7/30/2014 Recommendation Meeting
Queen Anne Mixed Use - 531 Queen Anne Ave. N., Seattle, WA 98109
DPD PROJECT #3014863

TABLE OF CONTENTS

EDG scheme

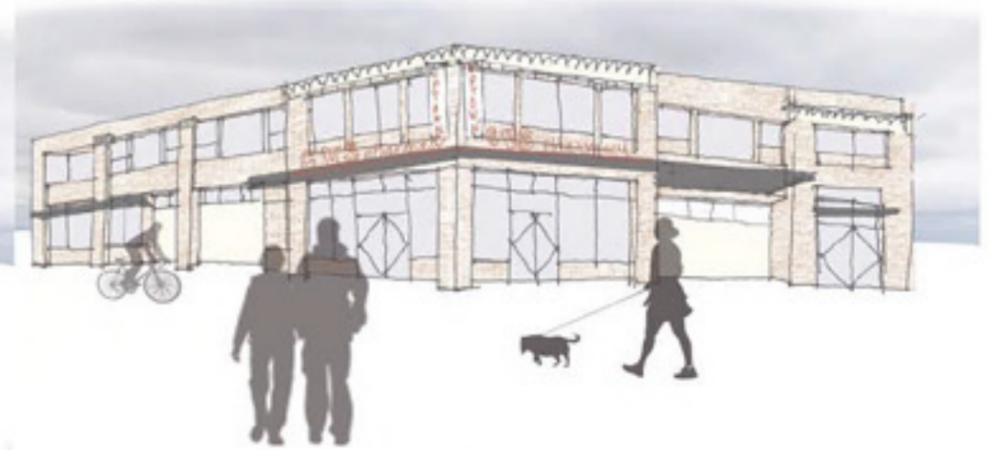
EDG Meeting #1: The Uptown neighborhood guidelines designate the intersection of Queen Anne Ave and Mercer St. as a gateway location. The site also lies within the “Heart of Uptown” character area. A chamfered corner may represent a valid response to the gateway location. However, the use of corporate imagery such as the curved, lattice-like cornice should not substitute for a corner design that fits the larger Uptown urban context. None of the three treatments of the corner presented at the initial review met the expectations described in the Uptown guidelines or by the Board.

EDG Meeting #2: Locating the micro-retail space on Mercer St. received the Board’s endorsement after debating whether the street had adequate pedestrian activity and the advisability of placing such a facility on an incline. (The slope on Madison St. does not appear to inhibit the success of the small restaurant Little Uncle’s on Capitol Hill.) Locating the retail niche on Mercer St. rather than near the bus stop received preference. Integrating the Metro rapid ride bus stop into the building also received enthusiastic support. See guidance under D-11 for further Board expectations of the bus stop. The architect suggested that outdoor seating for the adjacent Uptown Coffee Espresso and Bakery could spill over in front of the drugstore’s southern-most bay. The Board discussed the advisability of this notion; however, due to the vagueness of the details did not provide guidance.

EDG Meeting #2: The Board endorsed the two-story mass illustrated in the three scenarios presented at the meeting. The bulk of the mass approaches the property lines and, due to its relative size, anchors the corner intersection. In option #1, the exposed building frame reestablishes the horizontal and vertical datum lines and rhythm of the one and two story buildings along the adjacent streets and the Uptown neighborhood. The infill panels allow for adjustments in the vertical planes to accommodate the bus stop and the micro-retail use. Set back from the frame, the infill panels provide shadow and texture which will enhance the intimacy of the streetscape.

1. A continuous steel framed canopy is proposed along the entire length of the building. The team, in conversation with Metro, is intending to remove the two rapid ride stops, and provide those amenities as part of the building. Rapid Ride branding furnishings, and reader boards would be included. While only in its early stages, Metro is enthusiastic about the idea. This approach allows for what we believe in a less cluttered sidewalk and better waiting area for patrons. This idea is in direct response to community guidance.

2. A retail niche will be provided along Mercer Street. The niche will allow for locally owned businesses to lease a space. Such niches are a staple of Seattle neighborhoods, and occur in Capitol Hill, Downtown, and Pike Place Market, among other locations. The niche is expected to take up an entire structural bay, and have five feet of clear area from the property line. The niche would have some kind of folding or rolling gate of a high quality material and/or local artist design, to ensure visual interest during times when the retailer is closed.

3. The alley facades will be as open as possible on the ground floor and covered with aluminum or painted steel gates with a tight finely grained pattern to reflect the order of the main elevators. The early thoughts are that the grills would be part of the opening, allowing them to have a greater presence on the alley, and be of great interest to the adjacent condominiums and passerby. A green roof will be provided on the lower level, to not only aid in achieving the green factor, but also to provide visual relief for the condominium residents.

A1 SITE PLAN
1/20" = 1-0"

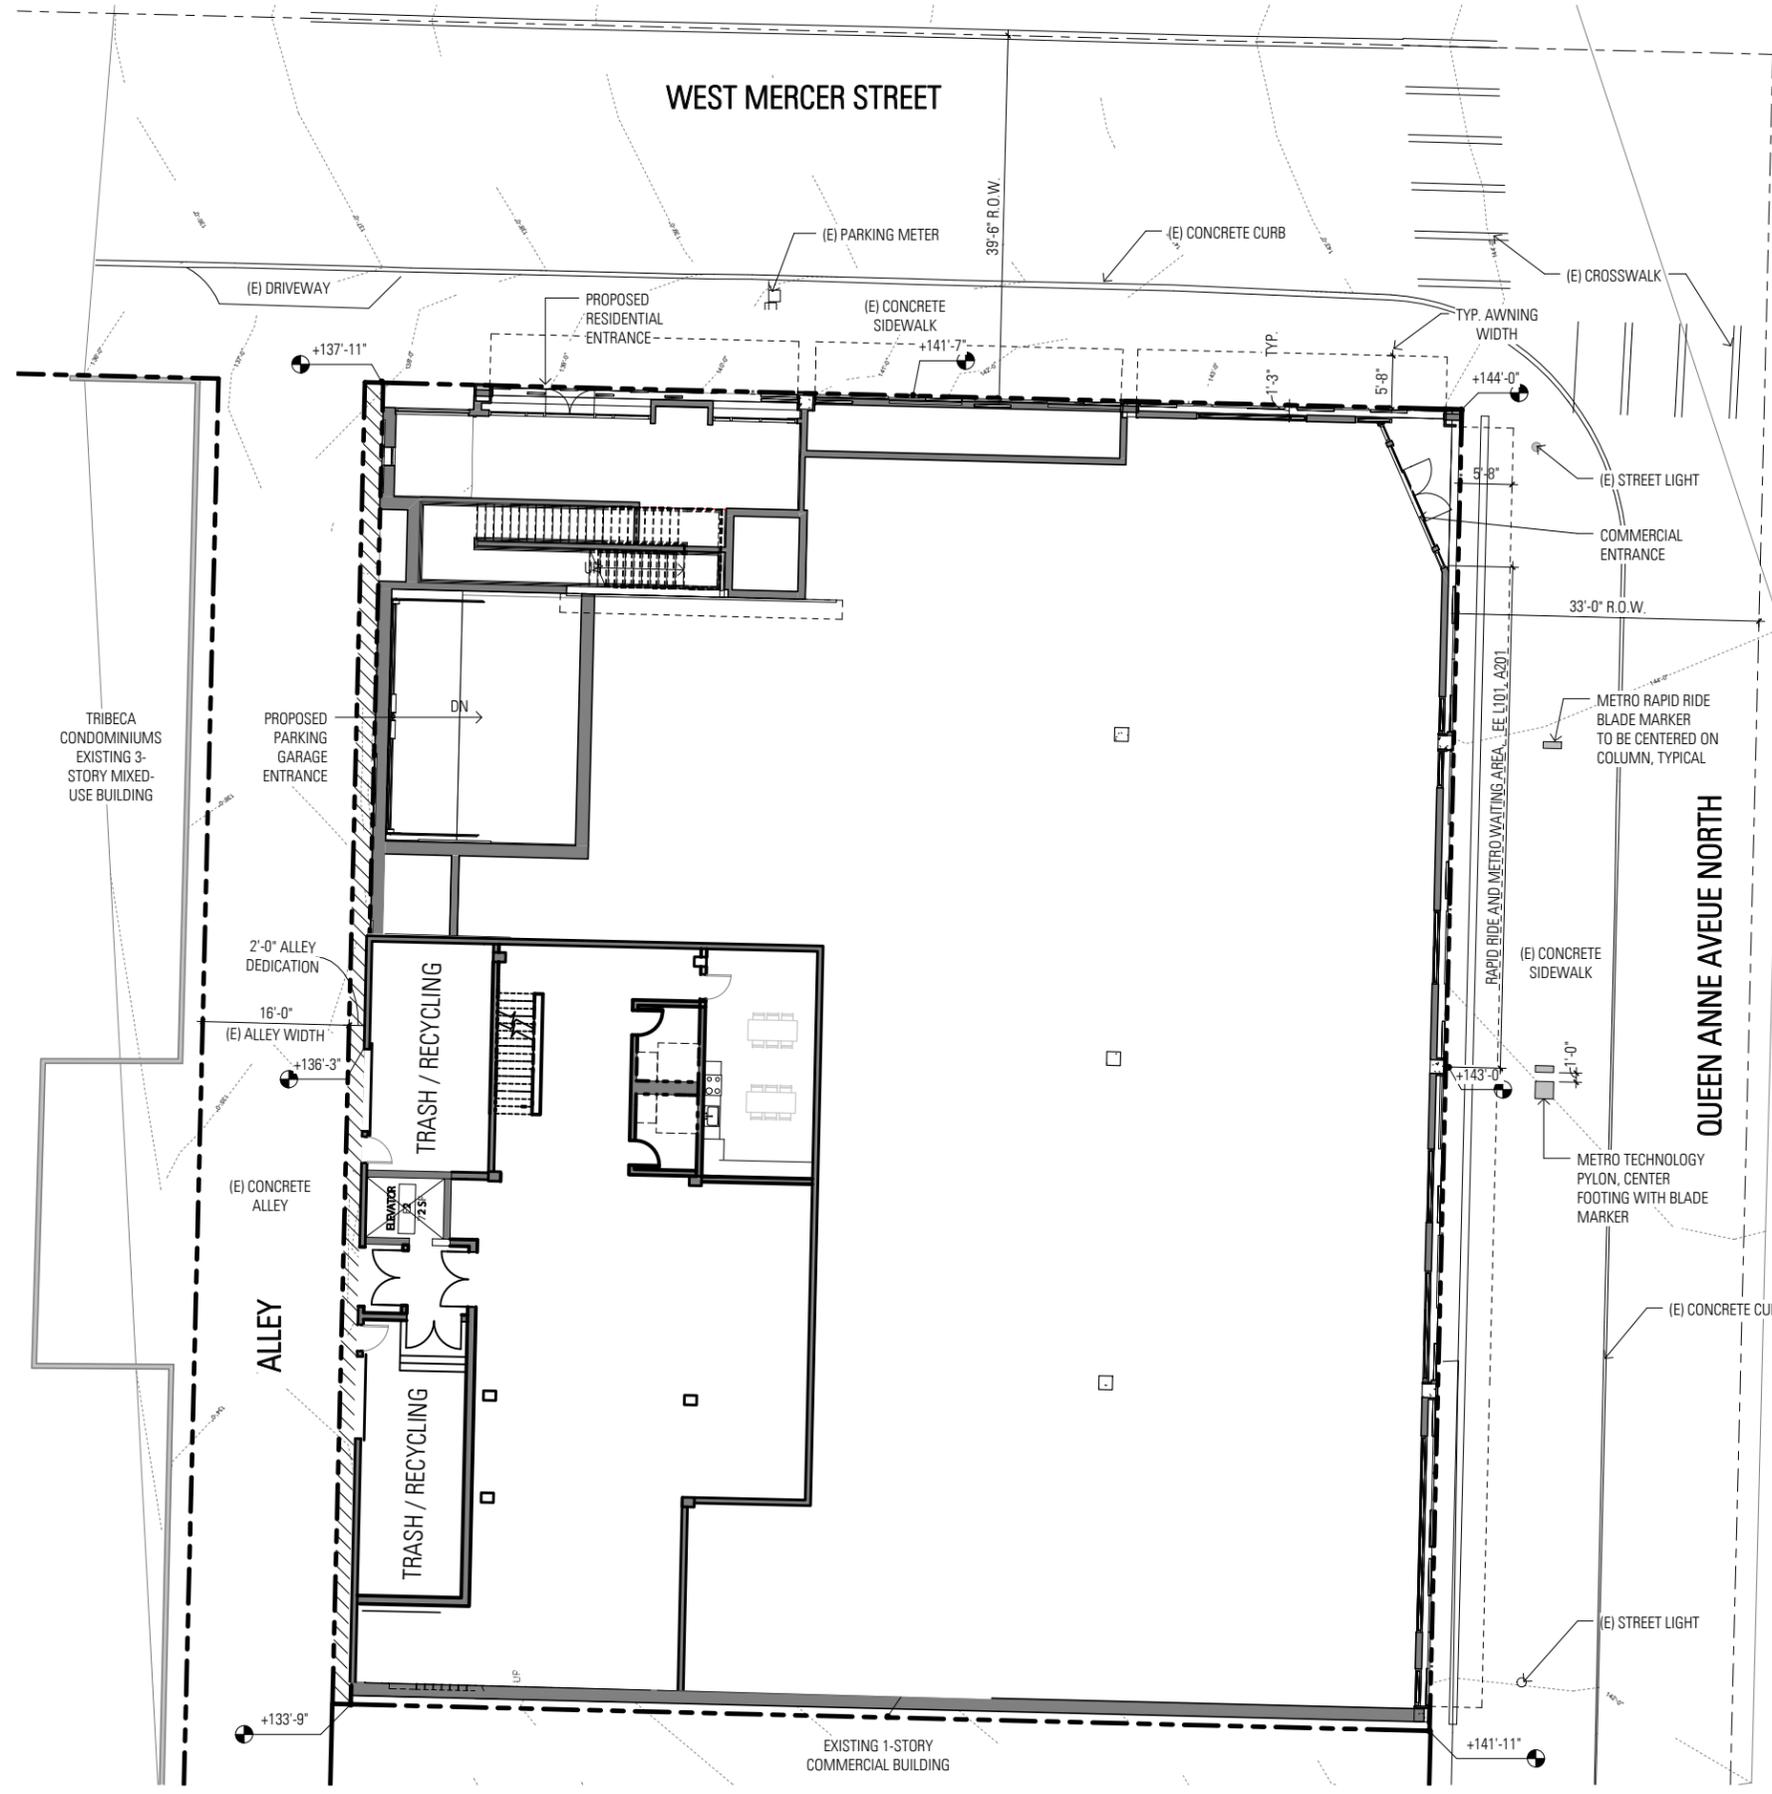
EDG Meeting # 2: The alley loading area and the entrance to the parking garage should not hinder the vehicular movement of the Tribeca residents entering and exiting their garage.

EDG Meeting #1: Garage access appears too close to the intersection of the alley and Mercer St. A transportation expert should study the proximity of the garage door both to the alley and to the Tribeca garage access across the alley and their impacts on one another. Ensure vehicular and pedestrian safety. The Board questioned the blank wall facing the alley. If the mezzanine, housing offices and storage, extends along the alley then the insertion of windows offers suitable relief and a means of daylight for the

Applicants Response: Access and loading activities have been addressed in our MUP corrections. Additional drawings were included showing compliance with Board guidance.

Applicants Response: The access study provided with MUP corrections examined eight different loading and vehicle access scenarios. All have been reviewed by SDOT and are satisfactory.

landscape plan

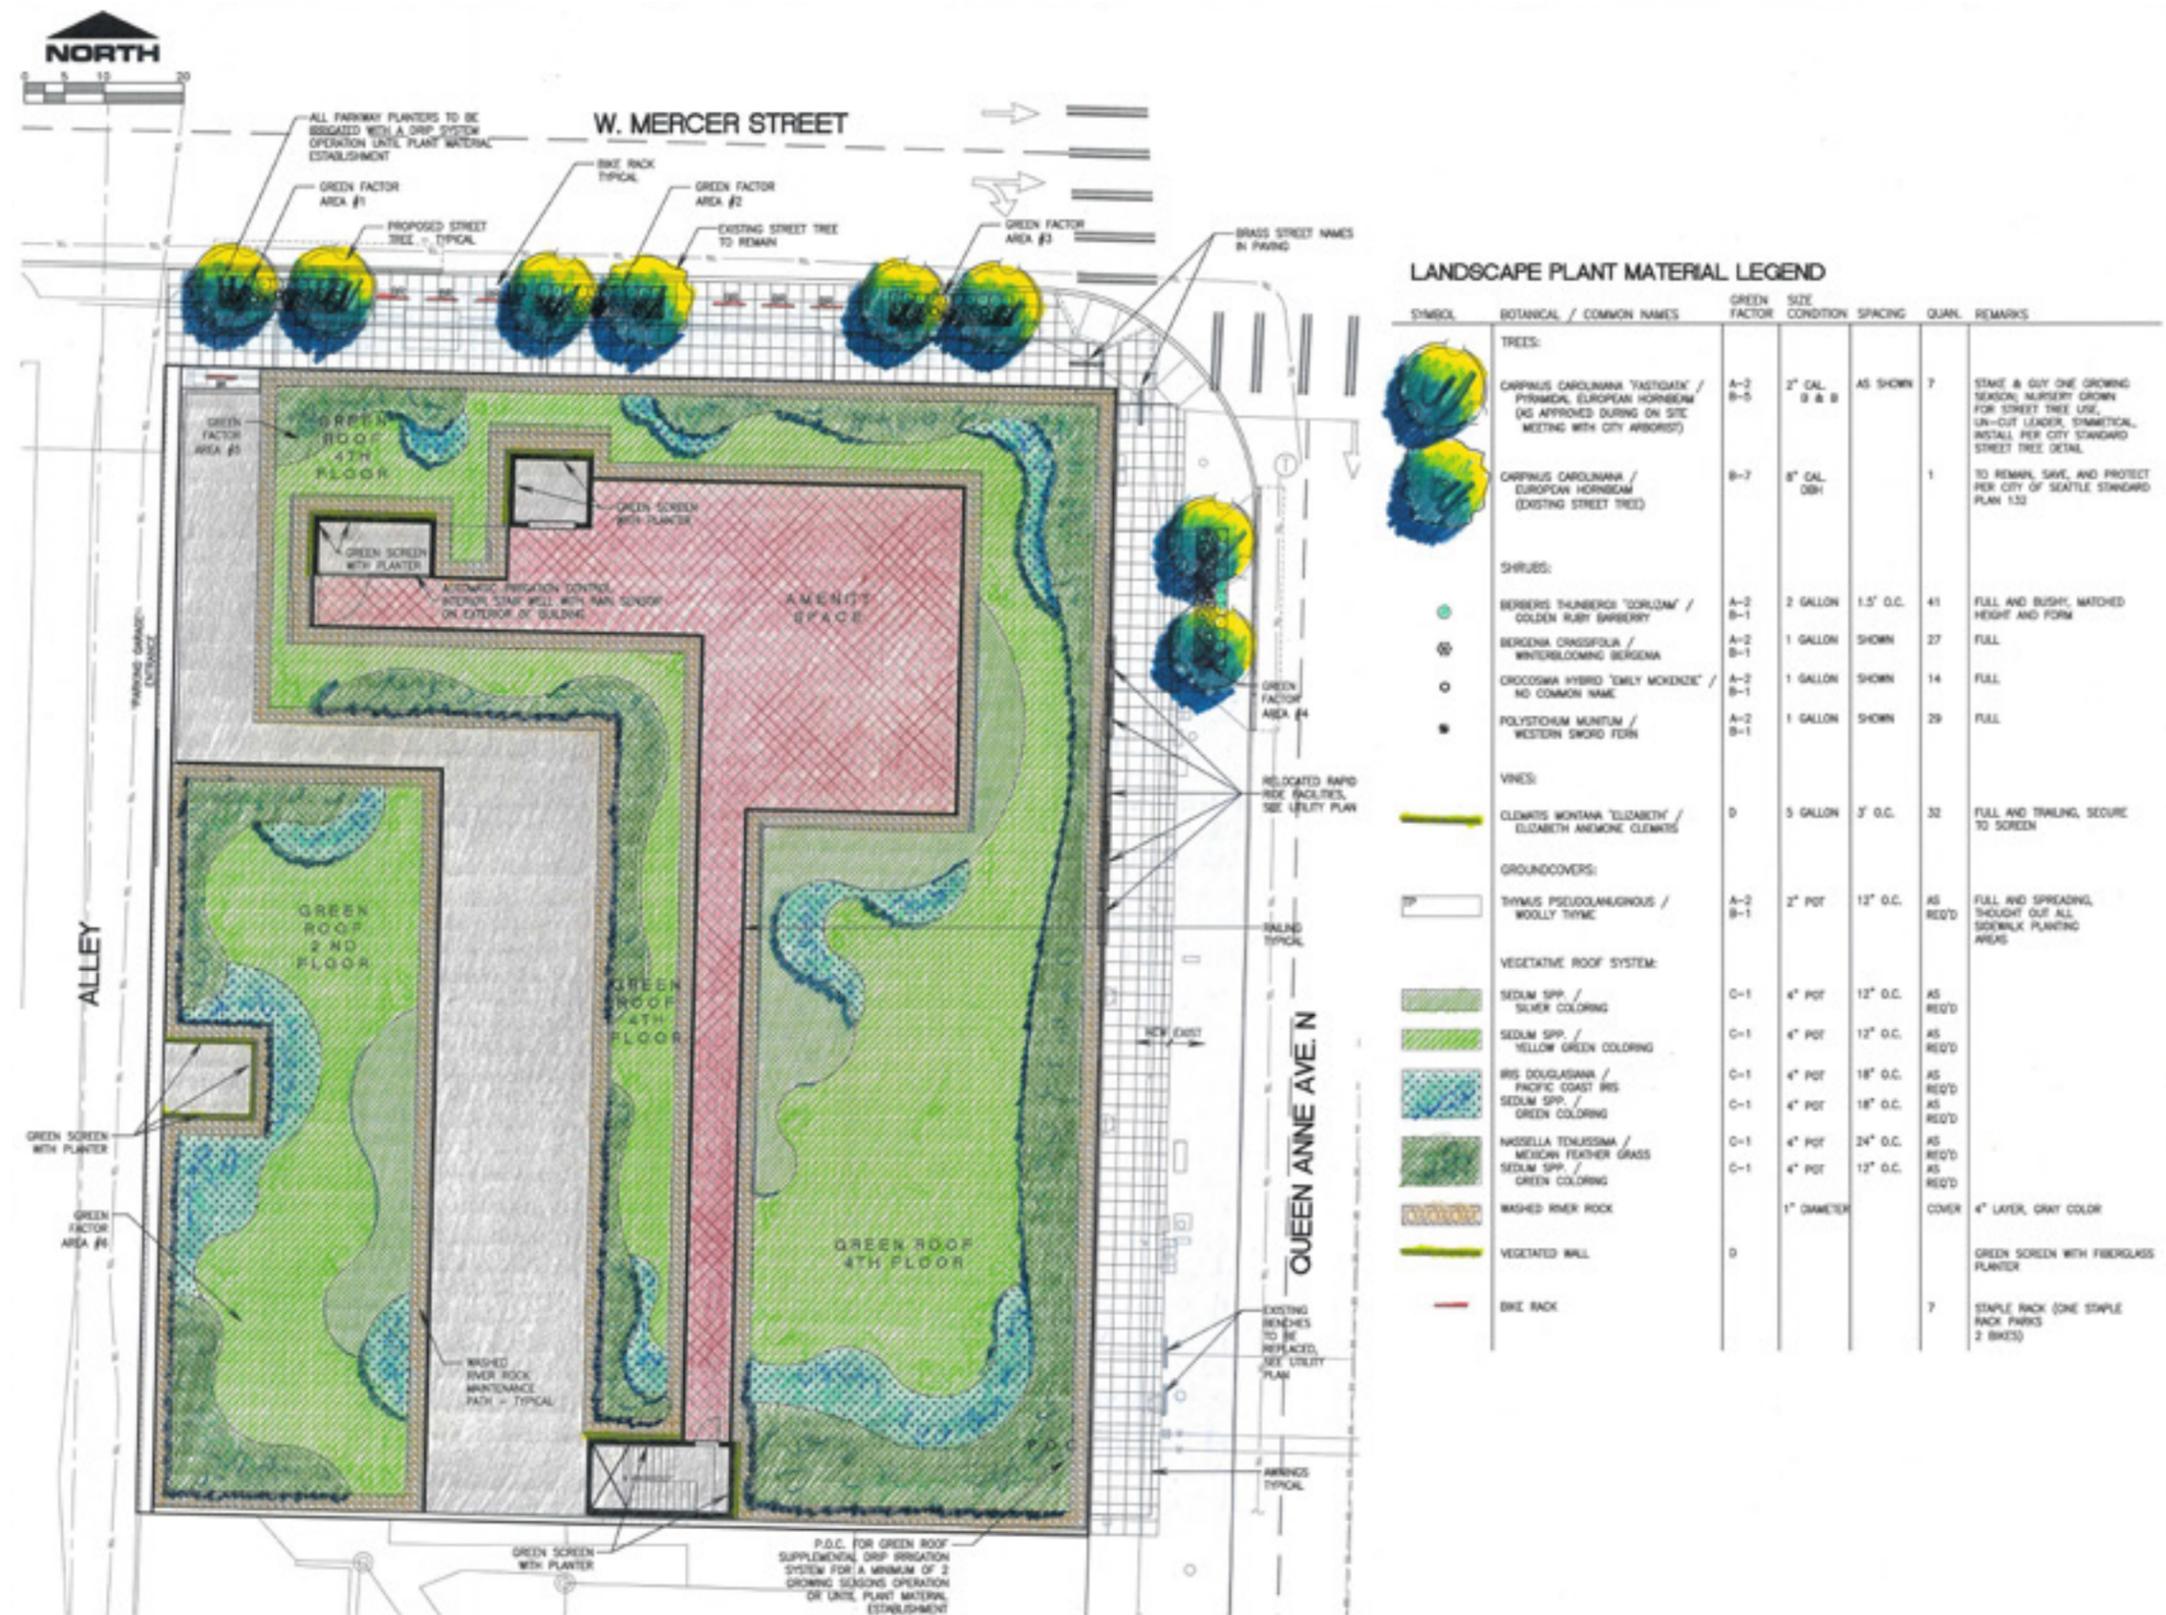
EDG #1: Partially blanketing an inaccessible roof with a non-visible green plantings received an unenthusiastic reception. The Board prefers an urban building set close to the street. This does not preclude, however, finding ways of landscaping the building and the rights of ways. As one member stated, “respond to the spirit of the green factor not to its calculation.” Meeting the green factor regulations requires creativity and ingenuity for this specific project.

EDG Meeting # 2: The Board generally supported the concept landscape plan and the desire to provide creative paving patterns and benches in the right-of-way. The development team should explore adding bike racks to portions of the right-of-way.

Applicants Response: The design has been simplified, so as not to compete with the other pedestrian amenities. The planting strip is as large as practical, given Metro requirements for their stop, as well as the need to provide sufficient short-term sidewalk bicycle parking. Bronze letters (to match historic precedents) identifying Queen Anne Avenue and Mercer Street will be cast at the intersection.
